N5244AS-01A

S E R V I C E N O T E

Supersedes:
N5244AS-01

N5244AS PNA Series Microwave Network Analyzers

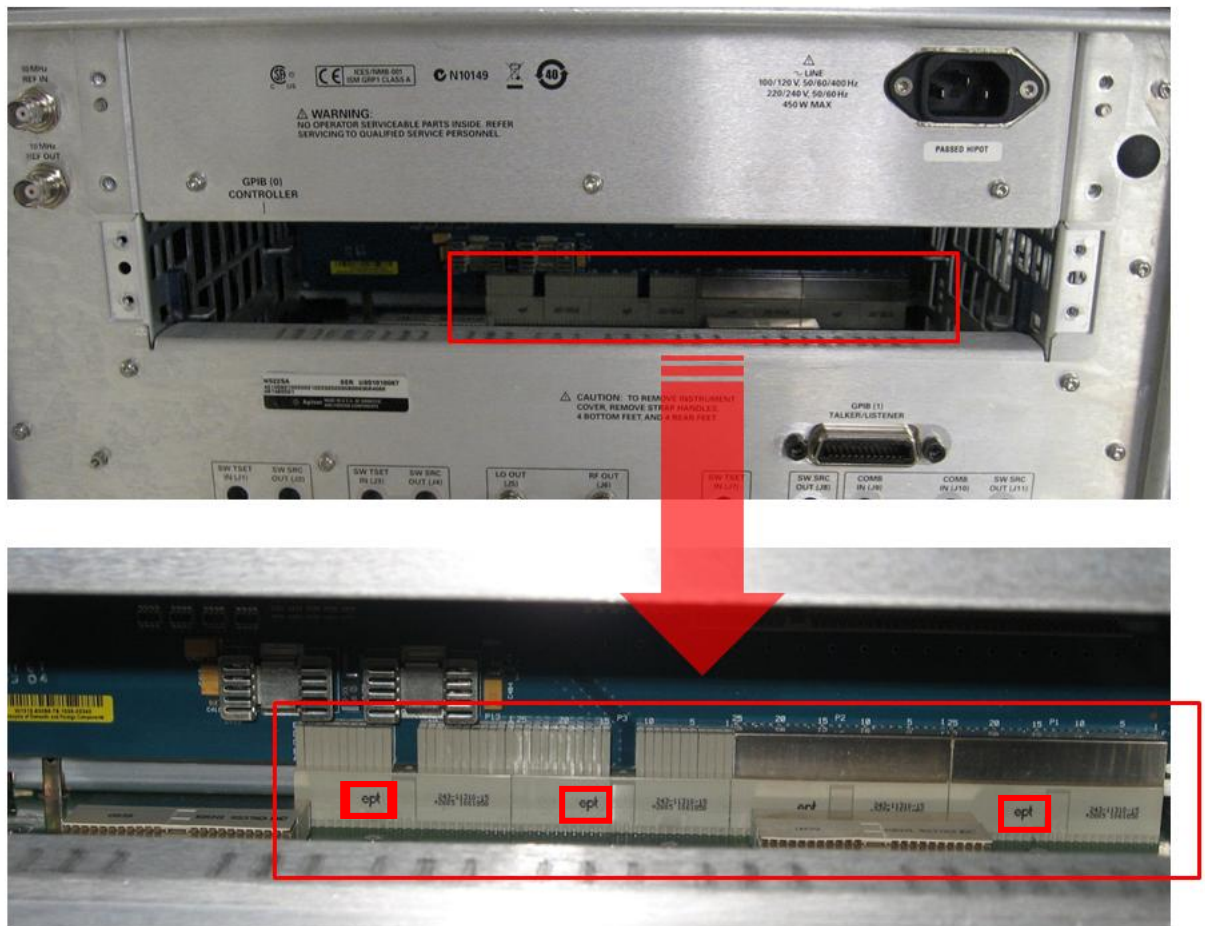
1. Remove the CPU assembly from the analyzer's rear panel. Refer to the PNA Service Guide chapter 7 section titled, "Removing and Replacing the CPU Board Assembly" for removal and reinstallation procedures. To view the online Service Guide, see the numbered list on the next page for instructions.
2. As per the photo below, inspect the system motherboard connector to see if it has one or more "ept" logos.

3. If the connector has one or more “ept” logos, return the analyzer to Agilent for replacement of the system motherboard. If the connector does not have one or more “ept” logos, email ctd-soco_support@agilent.com, providing the analyzer model and serial number and details of the malfunction symptoms.

4. *For Agilent Service Technicians only:* Only new boards without “ept” logos should be installed. Before installing the new board, look to see if it has one or more “ept” logos. If so, email ctd-soco_support@agilent.com, providing the analyzer model and serial number. Wait for further instructions in an email reply. New boards without “ept” logos can be installed. For installation instructions, refer to the PNA Service Guide chapter 7 section titled, “Removing and Replacing the System Motherboard.” To view the online Service Guide, see the numbered list on the next page for instructions.
